RE CAR RADIO SERVICE MANUAL QP67A.

# Information

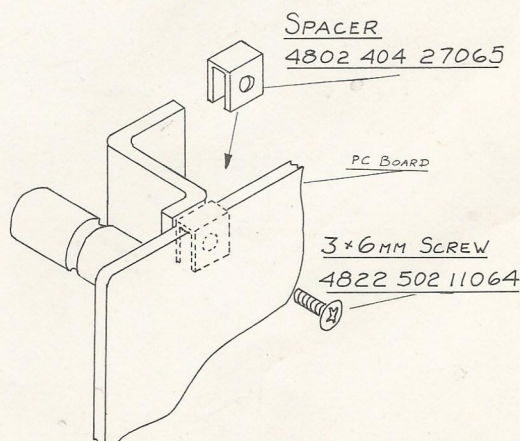
Re Car Radio 0P45:

- Fault - Buzzing noise either continuously or just when the receiver is turned on.  
Cause - Poor contact between I.C. heat sink and chassis  
Cure - Replace 3x6 mm screw with new one and add spacer 4802 404 27065 as per sketch.
